Intersection ID: 9046	Main Street: BRADFORD_DR	Cross Street: HOOVER_ST	Location:	N
ADA ID: 2B338219C3A7	Ramp Type: BlendTrans2	Initial Pass/Fail: Fail	Overall Compliance: No	Severity Score: 21.25

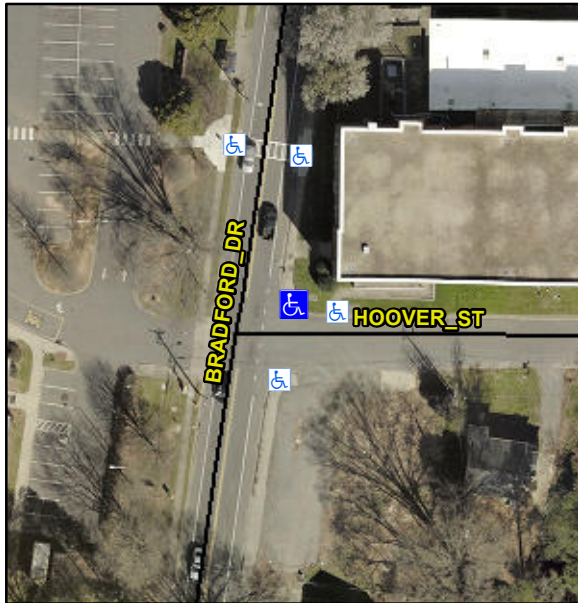
**NO RT SW**

**Not Found, R304.5.1, R304.5.3**

Compliance	Description	Data	Compliance	Description	Data
N/A	Ramp Length (in)	72.0	Yes	BlendTrans Slope (%)	3.1
No	Ramp Width (in)	36.0	No	BlendTrans XSlope (%)	5.1
N/A	Flare Type LT	N/A	N/A	Flare Type RT	N/A
N/A	Flare Slope LT (%)	N/A	N/A	Flare Slope RT (%)	N/A
N/A	Flare Traversable LT?	N/A	N/A	Flare Traversable RT?	N/A
N/A	Landing Length (in)	N/A	N/A	DWS Provided?	N/A
N/A	Landing Width (in)	N/A	N/A	DWS Contrast?	N/A
N/A	Landing Slope (%)	N/A	N/A	DWS Length (in)	N/A
N/A	Landing X Slope (%)	N/A	N/A	DWS Full Width?	N/A
N/A	Landing Curb? (Y/N)	N/A	N/A	DWS Offset (in)	N/A
N/A	Shared Landing?	N/A			
N/A	Gutter Ponding?	N/A	N/A	Gutter Slope (%)	N/A
N/A	Gutter Lip Ht (in)	N/A	N/A	Gutter X Slope (%)	N/A
N/A	Painted X Walk1?	No	N/A	Painted X Walk2?	N/A
	X Walk 1 Direction	To S		X Walk 2 Direction	N/A
	X Walk 1 Width (in)	N/A		X Walk 2 Width (in)	N/A
	X Walk 1 Slope (%)	0.2		X Walk 2 Slope (%)	N/A
	X Walk 1 X Slope (%)	6.5		X Walk 2 X Slope (%)	N/A

N/A	Ramp inside XWalk1?	N/A	N/A	Ramp inside XWalk2?	N/A
	Road Slope (%)	6.5		Clear Space?	N/A
	Road X Slope (%)	0.2	N/A	Clear Space to XWalk (in)	N/A
N/A	Any Obstructions?	N/A	N/A	Storm Grate/Utility Hazard?	N/A
	Obstruction Type			Storm Grate/Utility Type	
		N/A			N/A
			Yes	Surface Condition? (G/P)	Good
			No	Curb Slope (%)	16.2

**Remove & Replace Curb Ramp With Two New Directional Ramps or Equivalent.**
